December 12, 2019

**RE: Traffic Impact Study Addendum
Berry Hills Phase Eight**

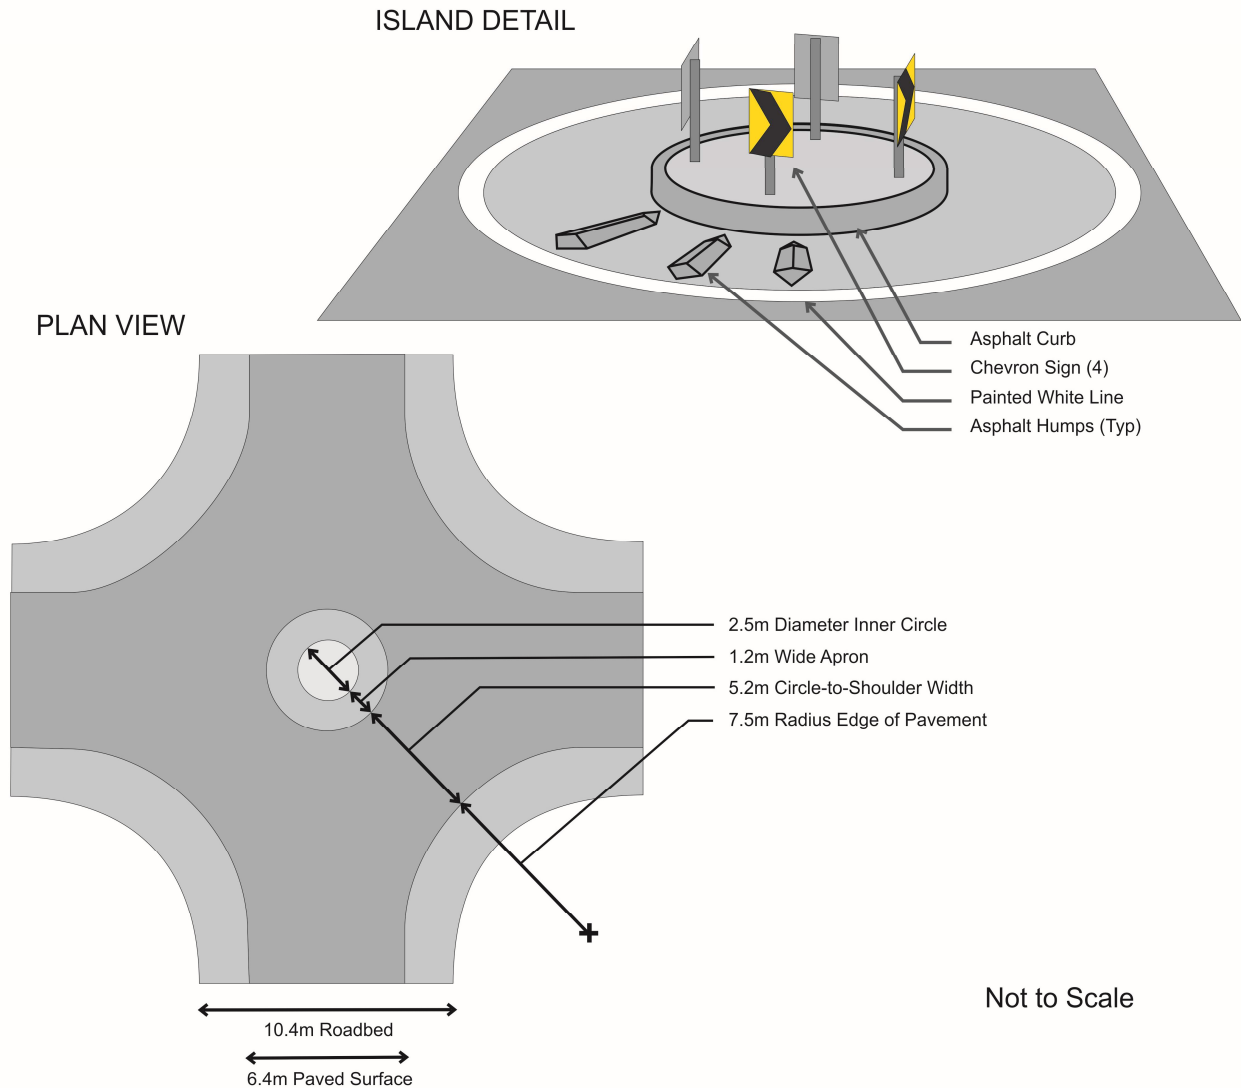
This daily volume warrants the consideration of traffic calming measures on Lively Road. Speed humps are already present on Lively Road and additional measures may not be required. HRM staff have suggested that a mini-traffic-circle at the intersection of the development site access road and Lively Road may help to supplement the traffic calming effect provided by the existing speed humps. At the request of the

Municipality, and recognizing that it has no standard for such a device, a conceptual sketch of a mini-traffic-circle at a local-local intersection has been provided below. The interior circle is only 2.5 meters in diameter, but an apron with radiating raised humps (or “ribs”) is added to increase the effective diameter of the circle without physically hampering the movement of larger trucks. The curb-to-shoulder width of 5.2 meters that results is well above the minimum of fifteen feet suggested by NACTO guidelines for facilities of this type.

We have found, however, that this type of intersection control can not be effectively implemented at a T-intersection, as is the case at the development site connection to Lively Road. The design relies on through traffic migrating onto the cross-street approach and this is not possible when one of the intersection legs is missing. As there are no four-leg intersections on Lively Road, this is not a good device for traffic calming.
